VACO INVESTMENTS (WAIPU PROJECT) LIMITED
RESOURCE CONSENT APPLICATION REFERENCE: SL2300006 AT MILLBROOK ROAD, WAIPU
S92(1) TRANSPORT RESPONSE

In item 2 of their Section 92(1) request regarding Resource Consent Application Reference: SL2300006 at Millbrook Road, Waipu, the Whangarei District Council advised:

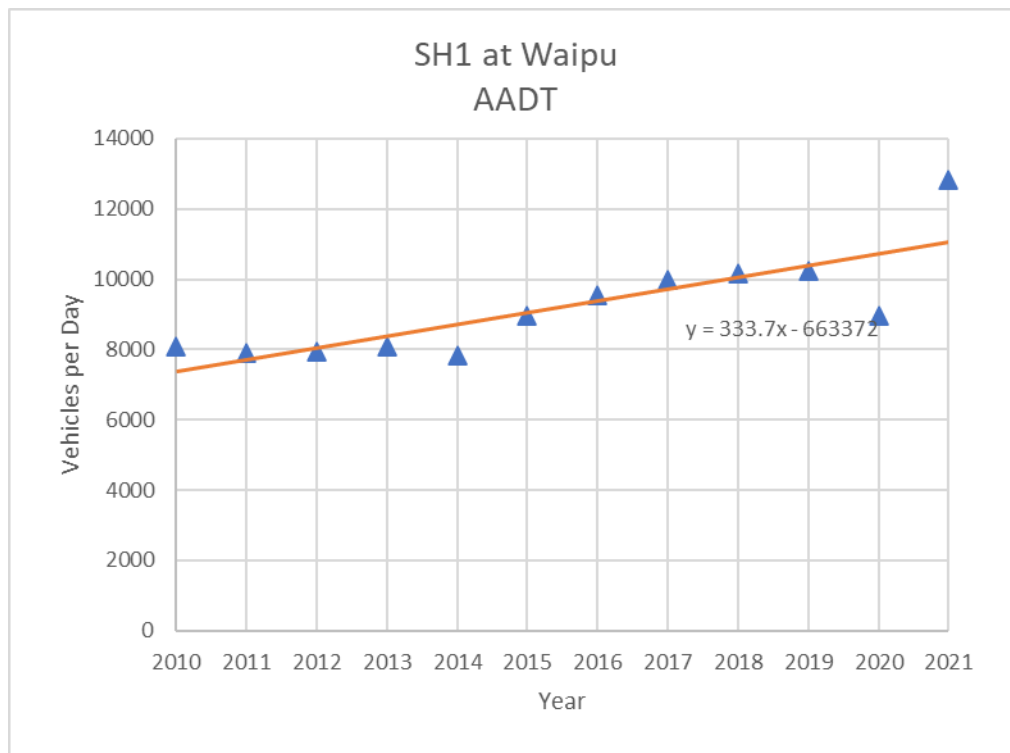
3. [We consider that the linked trip reduction factor adopted by the ITA may be overly optimistic. We also consider that further evidence is required to justify the pass-by trip reduction factor adopted by the ITA. We recommend that further evidence and sensitivity testing is provided.](#)

As suggested by the reviewer, an intercept survey was undertaken at The Grange, Warkworth, on Friday 16 June 2023 from 4:30pm to 6:30pm. Of 31 observations, 18 (58%) were pass-by trips. 13 trips also included a trip to another activity that was located within the same site (The Grange) and another three trips included a trip to the local supermarket. As the proposed Waipu Gateway service centre will include a supermarket, these three trips would also be linked trips, i.e., trips that include a trip to another activity that would be located in the Waipu Service centre, meaning for Waipu a total of 16 (52%) linked trips. Of 13 linked trips where the other activity was within The Grange, seven (54%) went to BP first.

These surveyed rates have been used for the traffic modelling in this memorandum.

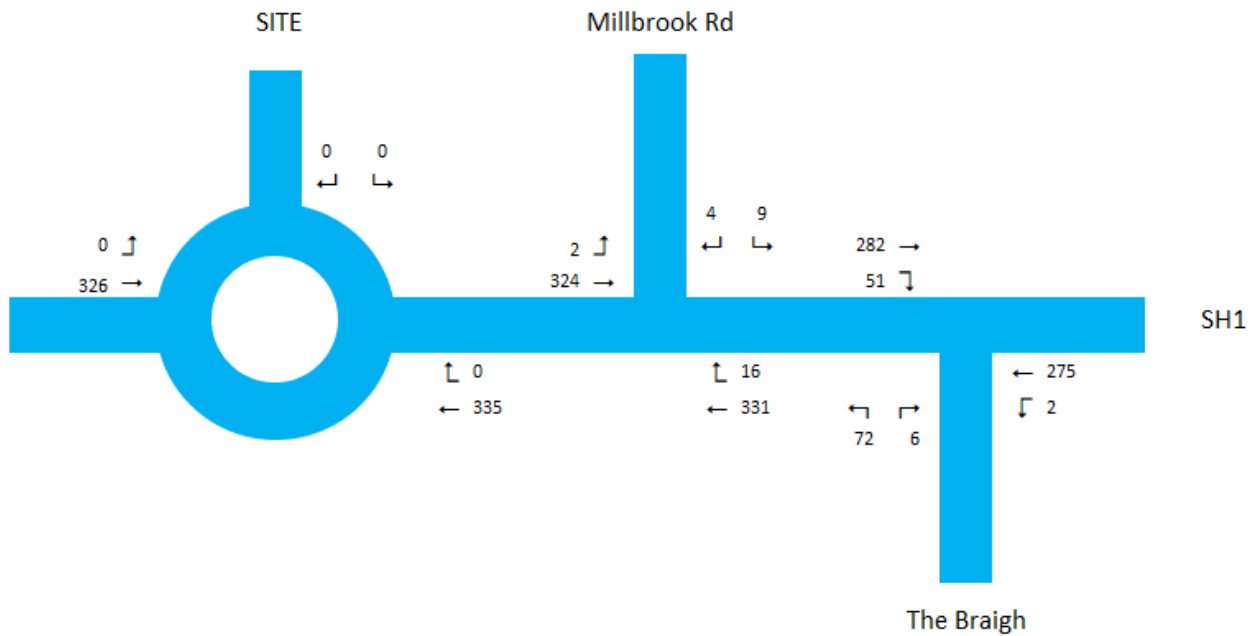
12. We are concerned that the reduction of the existing southbound passing lane by approximately 300m will have a negative effect on the safe and efficient function of the passing lane.

The existing southbound passing lane is some 1km long excluding tapers. As noted in Section 5.6.3 of Austroads Guide to Road Design Part 1, Overtaking Establishment Sight Distance (OED) is calculated as follows:

Thus, overtaking establishment sight distance is proportional to operating speed.

The existing southbound operating speed entering the passing lane is 100km/h. With the roundabout in place, the southbound speed through the roundabout will be limited to 50km/h and the speed entering the passing lane 100m downstream will be some 70km/h, a reduction of 30%. Thus, to maintain its current level of service, the passing lane can be 30% shorter, which is what is proposed.

ESTIMATED 2032 HOLIDAY PEAK HOUR TURNING MOVEMENTS (EXCL DEVELOPMENT TRAFFIC)

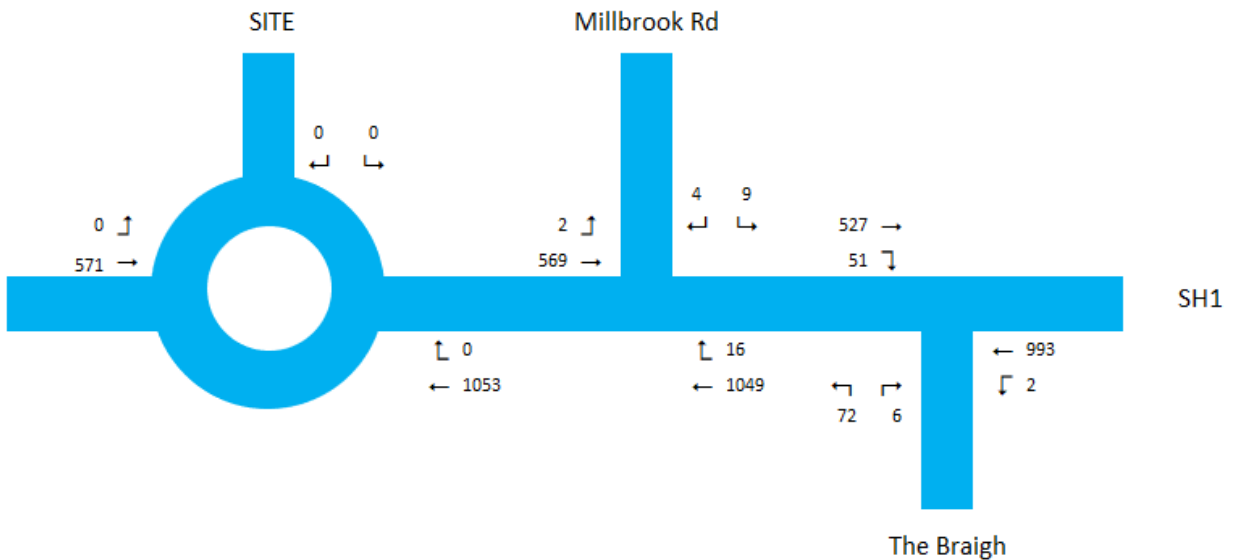
6. We recommend that the ITA is verified to ensure that all traffic volume inputs into SIDRA are consistent with the assumptions stated in the body of the ITA report. We recommend that a single network diagram is presented showing traffic volumes on approaches that includes all SIDRA scenarios, so changes in traffic movements can be more easily compared and verified.

The reviewer suggests that *“some input volumes do not seem to match other sections of the ITA. For example, the 2032 base case SIDRA scenario for SH1/The Braigh has 915 veh/hr (north approach) and 606 veh/hr (south approach) flows, however Appendix C Table 1 states 1,053 (north approach) and 571 veh/hr (south approach).”*

The reviewer has misunderstood what the volumes at Appendix C Table 1 represent. These are the estimated 2032 holiday peak hour volumes northbound and southbound on SH1 in the vicinity of count station ID: 01N00309, which is to the south of both the Milbrook Road intersection and the subject site. They should not be compared to the approach volumes on SH1 at The Braigh.

Nevertheless, there do appear to be some discrepancies between estimated and modeled turning movement volumes. To minimise the potential for future confusion, we have appended to this S92 response the spreadsheet used to calculate the turning movements from the updated GFAs, trip rates, and pass-by and linked trip proportions mentioned above in the responses to comments 1-3. The spreadsheet can be downloaded from the following link:
